CONWAY
HISTORIC DISTRICT COMMISSION
MAY

CONWAY HISTORIC DISTRICT COMMISSION MEETING

**OLD CONWAY DESIGN OVERLAY DISTRICT
CERTIFICATE OF APPROPRIATENESS REVIEW
ROBINSON & CENTER CHURCH OF CHRIST
PARKING LOT ADDITION
709 & 715 GROVE STREET**

Address. 709 & 715 Grove Street

Proposed Overflow Parking Lot at 709 & 715 Grove Street

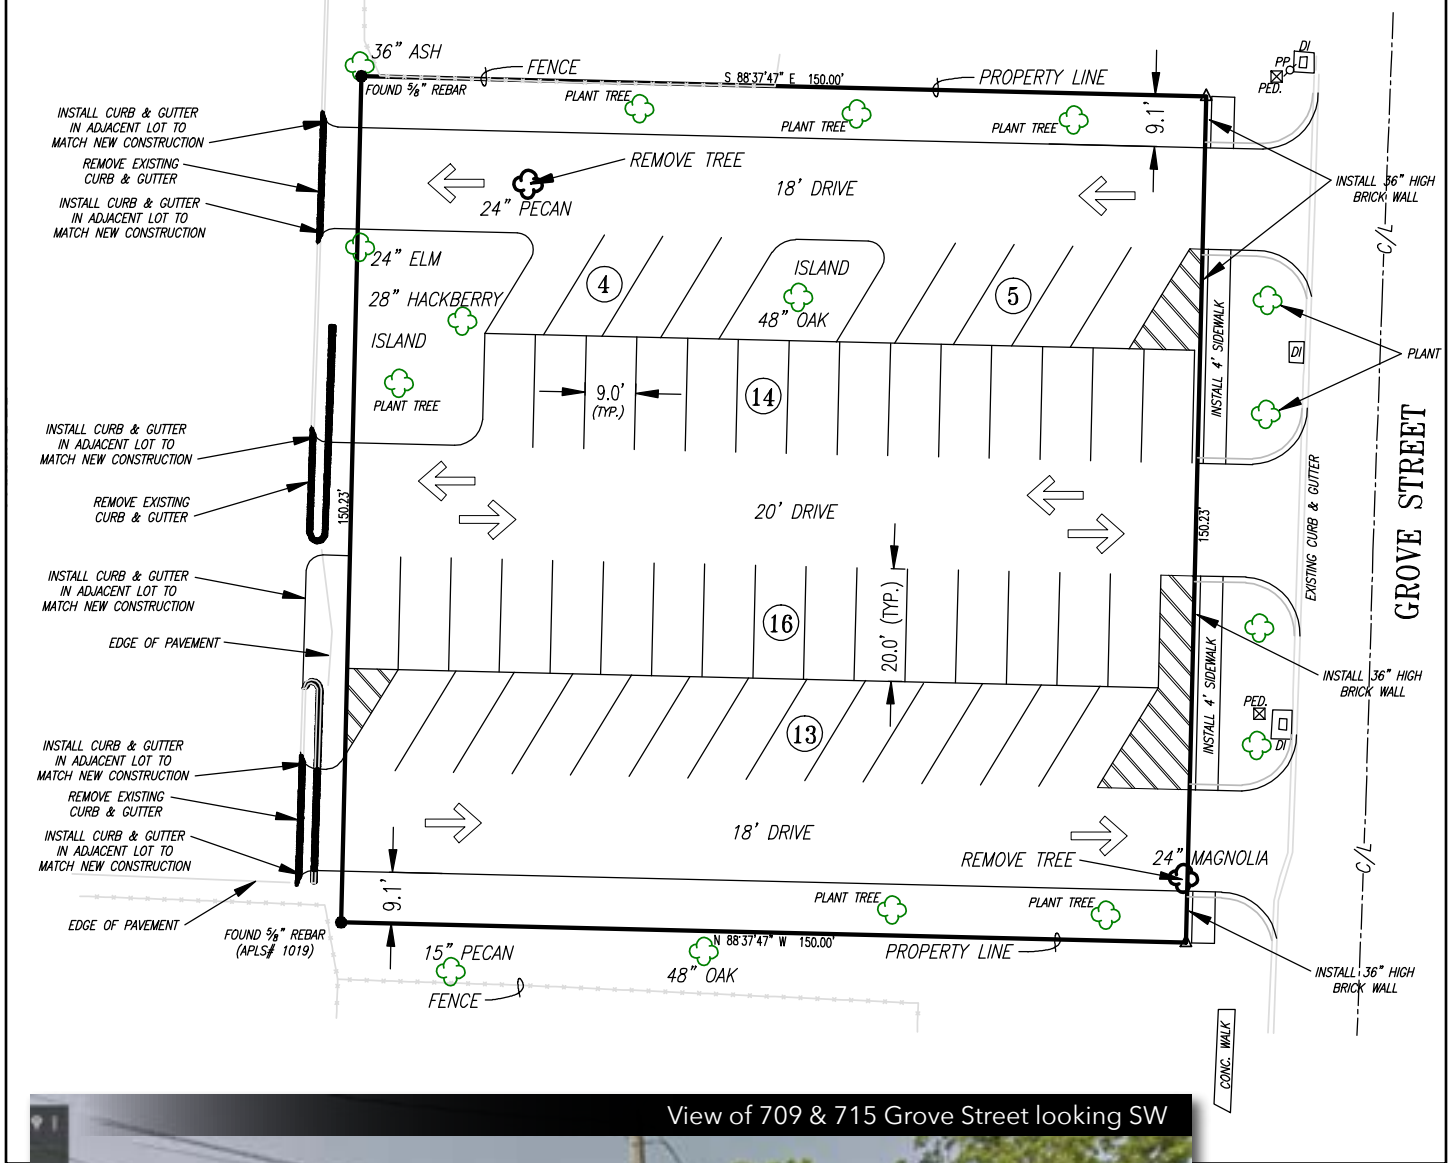
Lot Coverage. Lot coverage will remain unchanged. The lot is currently open and permeable. If the areas sown with hatched striping were made into permeable landscape areas, around 27% of the lot will be made impermeable. The Urban Transition area allows a range of coverage from 60% to 100%. This coverage percentage is appropriate, however the Commission should give consideration to requiring that the non-permeable hatched pavement areas be constructed as permeable landscaping areas.

Driveway/Parking/Carport. The proposed curbed and guttered parking lot is an addition to the existing parking lot to the east. Curbs and islands on the east parking lot will be reconfigured to match the new parking lot drive aisles. The parking lot would create 52 additional parking spaces. The 3 new drive aisles would provide additional access to the existing parking lot.

Tree preservation. Several significant trees will be affected by this project. However, the parking lot has been designed to maximize the preservation of as many large trees as possible. A 24" pecan and 24" magnolia will need to be removed in order to provide drive aisle access. A large elm, hackberry, and oak have been preserved. Additional trees will also be planted around the perimeter and Grove Street frontage as screening and remediation. These trees should be 2" caliper canopy trees at the time of planting.

Lighting. Any new lighting should be inward, downward, and shrouded so as to stay within the bounds of the property. No lighting is shown on the plans. The existing parking lot has one pole with a "night watcher" flood light and typical sodium street lamp. Any new parking lot pole lighting should be modern LED "shoebox" or similar shielded fixtures. Planning Dept. development review regulations state that a pole mounted parking light may be no more than 25 feet tall and must use shielded lighting limiting light to the inside of the property.

1. Parking lot shall be constructed as submitted. Areas shown with hatched pattern shall be grass landscaped areas and not asphalt/pavement.
2. The 24" pecan and 24" magnolia may be removed. Best tree preservation practices as outlined in the Old Conway Design Overlay District Pattern Book shall be used during construction. 9 new 2" caliper d.b.h. canopy trees shall be planted as shown on submitted plans. (*Section 6.A.Landscaping and Tree Preservation and Section 6.B.Trees - also Conway Development Review Regulations*)
3. Low screening brick walls shall be constructed along the Grove Street frontage as shown. (*Section 6.C.Off Street Parking*)
4. Lighting shall be directed inward, downward, and shrouded. Parking Light poles shall be no more than 25 feet in height. (*Section 6.A.Lighting - also Conway Development Review Regulations*)
